# TECHNICAL SERVICE BULLETIN

Bulletin Number: **V-05-02**

### SUBJECT: INSUFFICIENT TORQUE ON FRONT FORK TUBE PINCH BOLTS

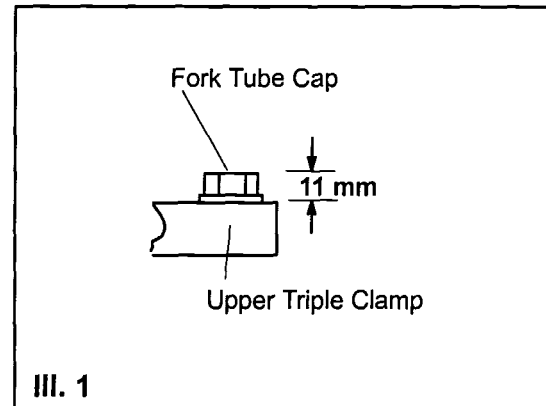
1. Measure the height of both left and right fork tubes in the upper triple clamp. The top of the fork cap should be 11mm (.433inch) above the top surface of the upper triple clamp as shown in III. 1.

**If tube height is unequal or not at specified height:**

2. Secure the motorcycle with the front wheel raised off the ground.
3. Loosen pinch bolts on upper and lower triple clamps.

4. Adjust tube height in triple clamps until both are equal and at specified height.

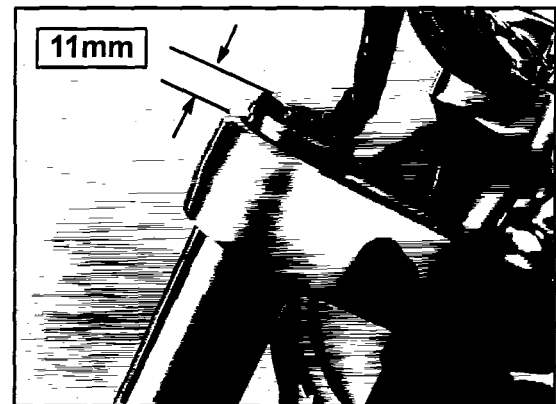
**When tubes are equal and at proper height:**

5. Torque lower triple clamp pinch bolts to 35 lb.-ft. (47.5 Nm).
6. Torque upper triple clamp pinch bolts to 35 lb.-ft. (47.5 Nm).
7. Lower the jack.
8. Apply front brake firmly and pump the front fork to check for smooth operation.
